**From:** John Roach <john@jmroach.com>  
**Sent:** Wednesday, November 07, 2018 3:03 PM  
**To:** Sarah Burdette  
**Cc:** Courtney Roach; Pat Roach; Vicki Geiger; 'Jason Pansier'; Charlotte Nagel; Joan Pansier (joan.pansier@yahoo.com)  
**Subject:** RE: Ledgeview Farm, LLC

As I am sure you are aware, Ledgeview Farm submitted a new Livestock Facility Siting License on November 5, 2018. Would you please insert the attached email from Brown County stating that the changed location does not require a new Animal Waste Storage permit from Brown County? I just received confirmation today. Please insert the email in the Specifications document, just before the Table of Contents and after the email from DNR. If you prefer, Roach & Associates would be happy to come to your office and insert the email into the original and copies of the Specifications. Please let me know your preference.  
Thank you.

Here is the approval from DNR to rotate the Ledgeview WSF to meet the setback requirements.

Subject: Conditional Approval of Plans & Specifications for a Waste Storage Facilities and Transfer Systems and a Grant of Waiver for Well Setback at, Ledgeview Farms, LLC, (Heifer Farm) at Sec 28, T2

SITE PLAN

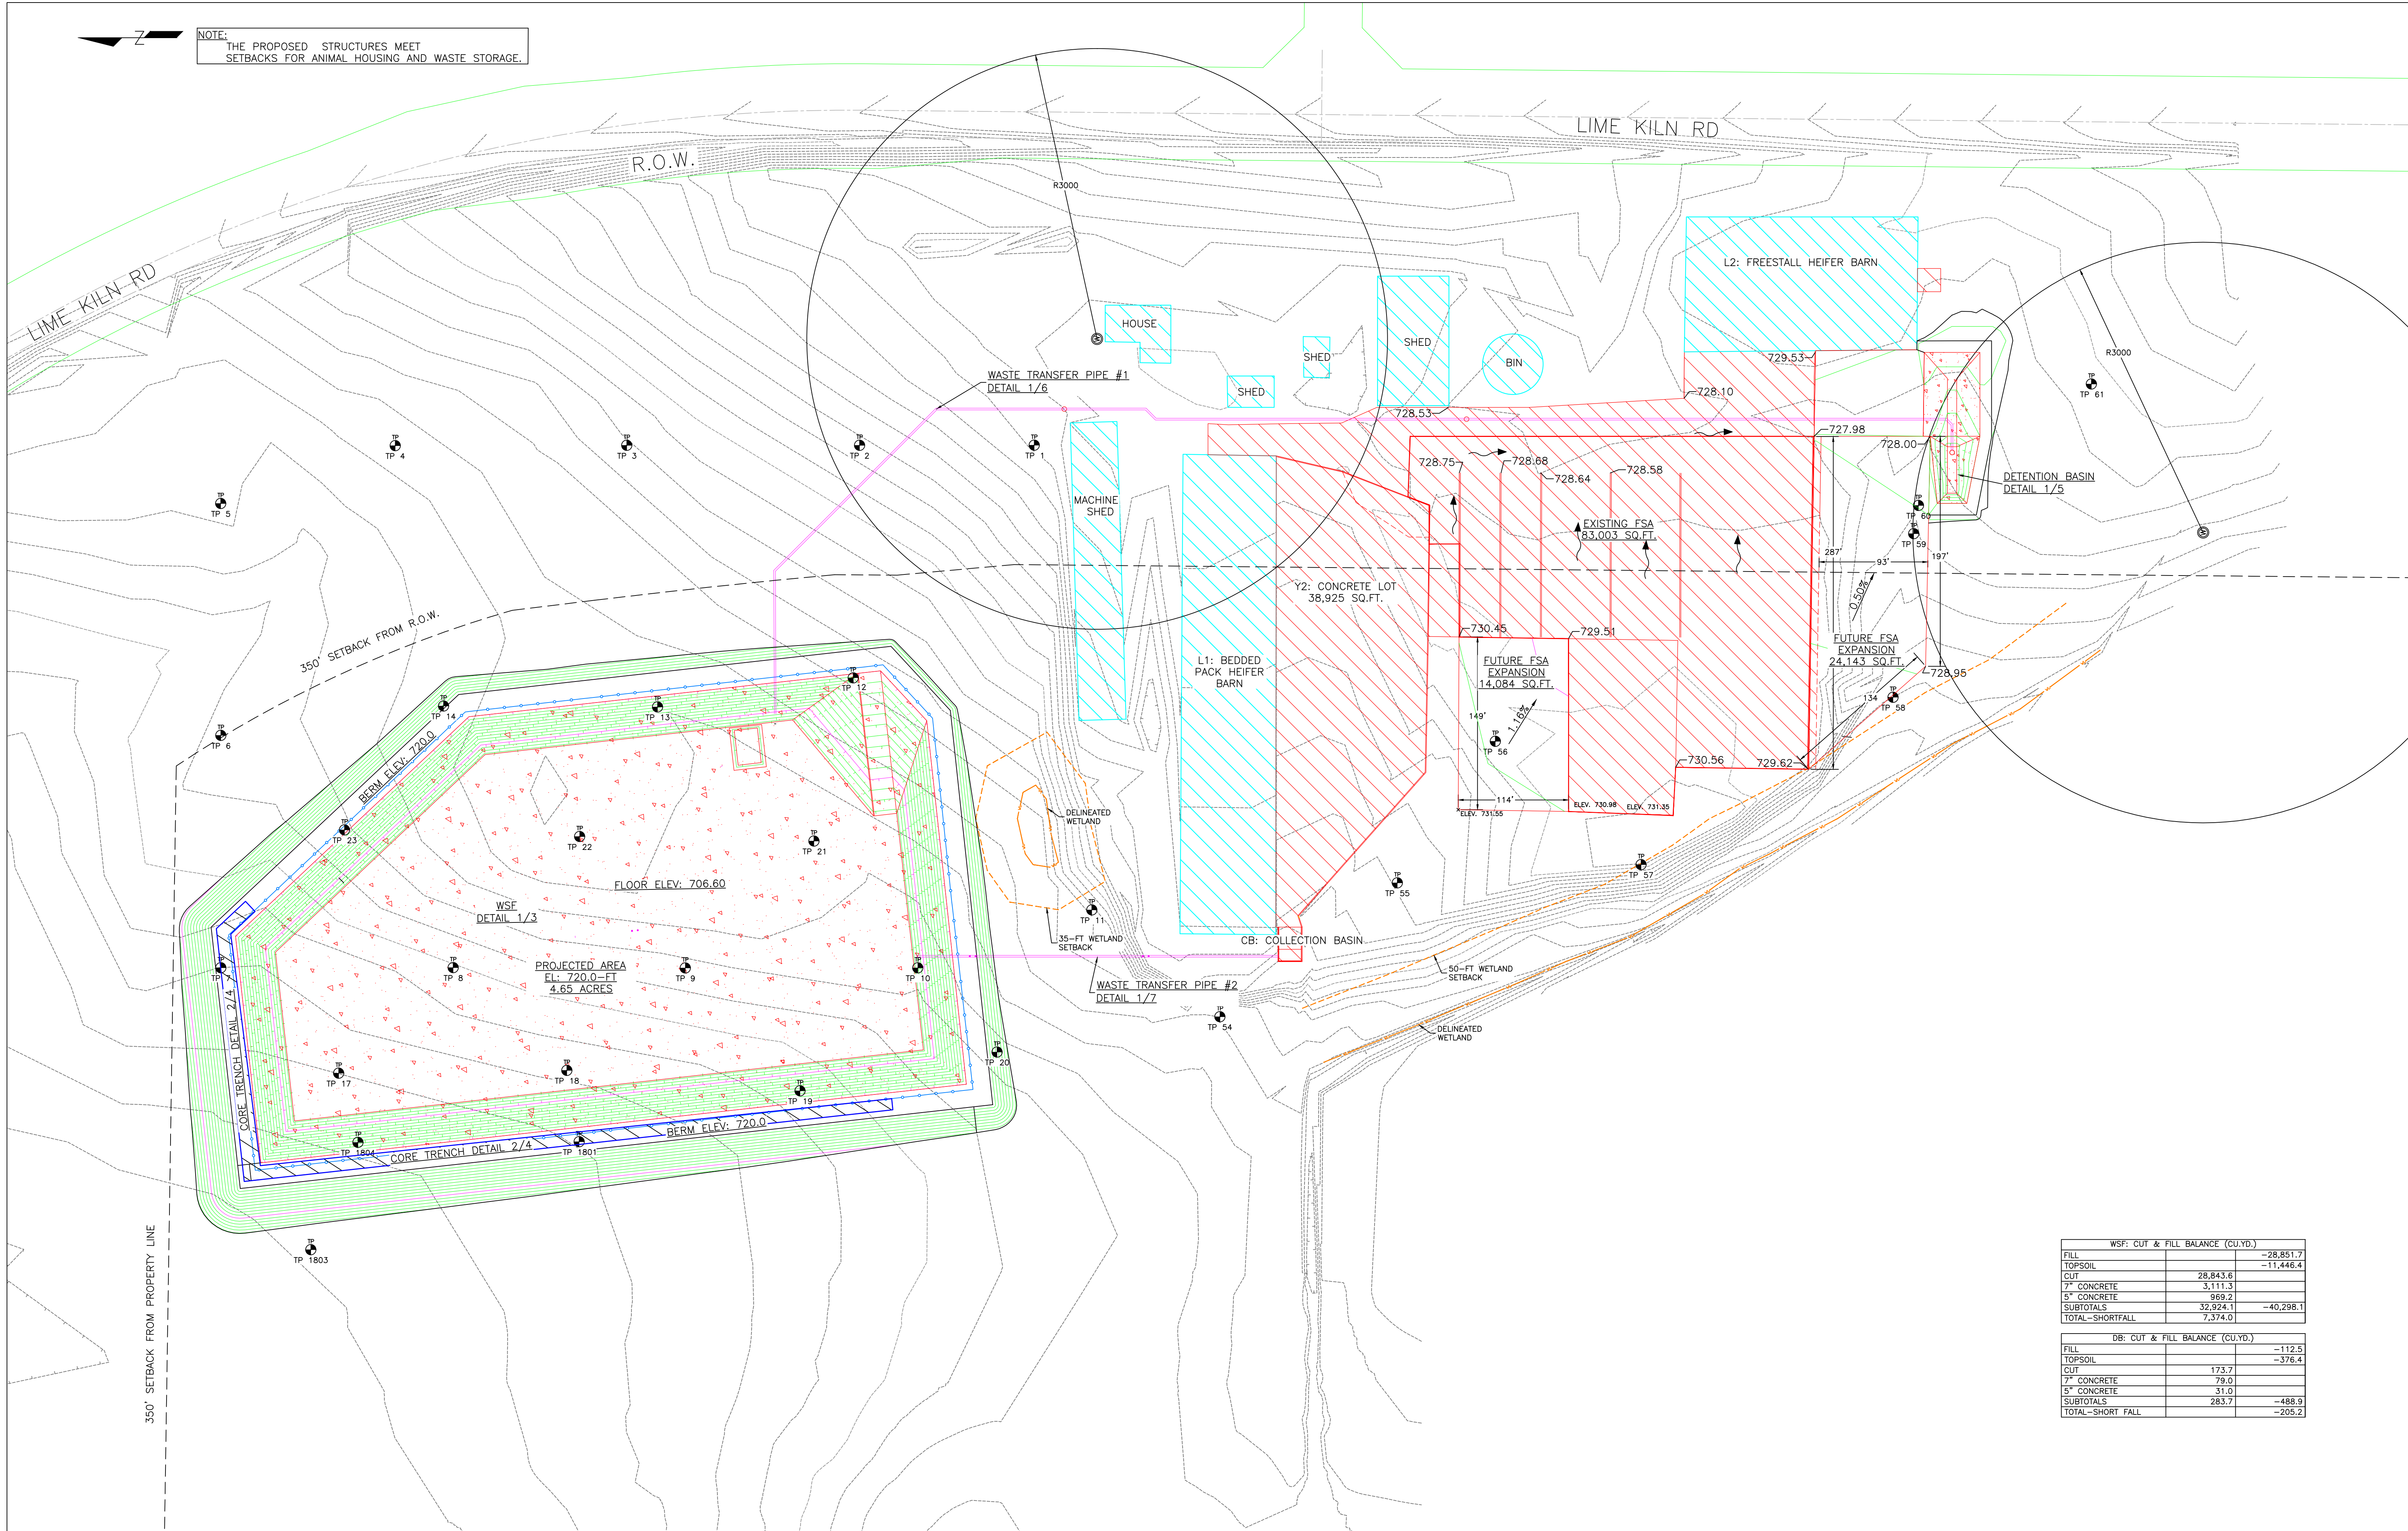
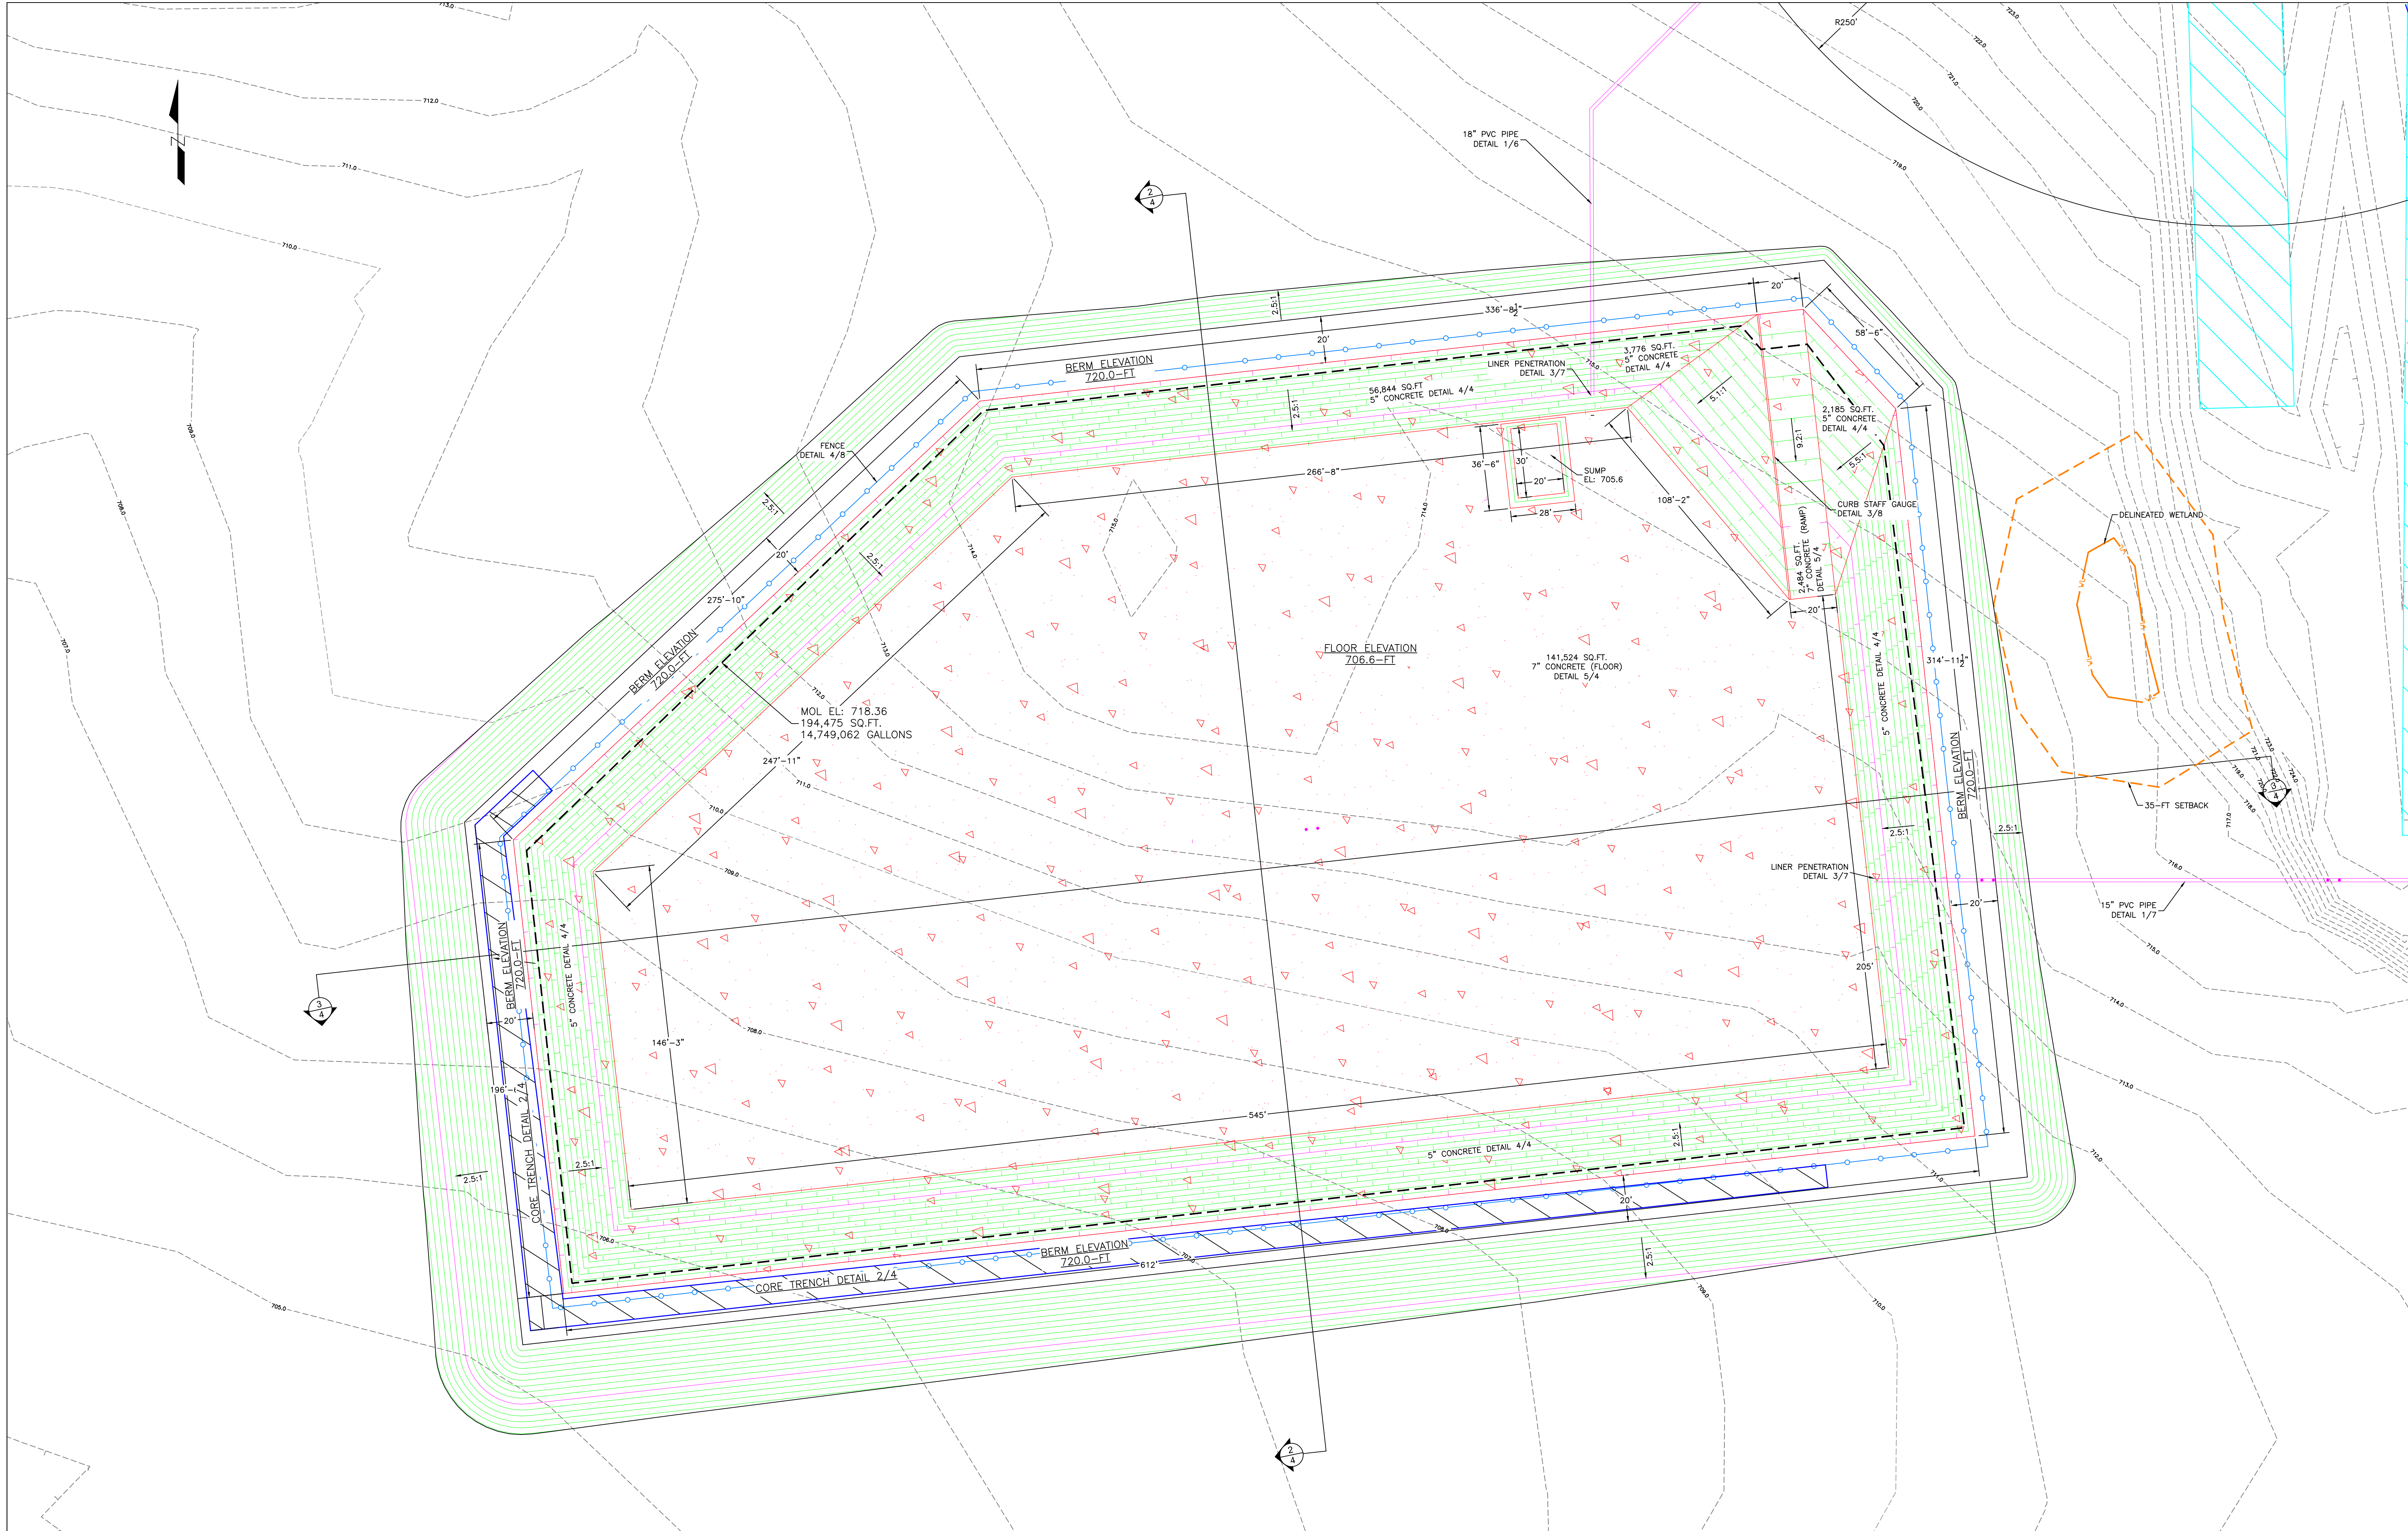
As we discussed at the Ledgeview site we want to rotate the WSF to meet setback requirements. Attached is a planview that shows the location of the WSF that you approved and the location of the WSF that we are

- 4) On November 5, 2018 Jeff Kreider of WDNR issued an email approval to allow the W2 WSF to be rotated to its current footprint as is shown on the Plans and Specifications found in Attachment 1. The WDNR approval email is attached.

This email serves as my approval for the rotating the waste storage pond at the satellite farm that has been approved. The change doesn't require a letter approval. This email should be included with the post-construction report as well as all changes from what was originally approved.

After review it has been determined that plans do not need to be re-submitted for this change in orientation of the proposed
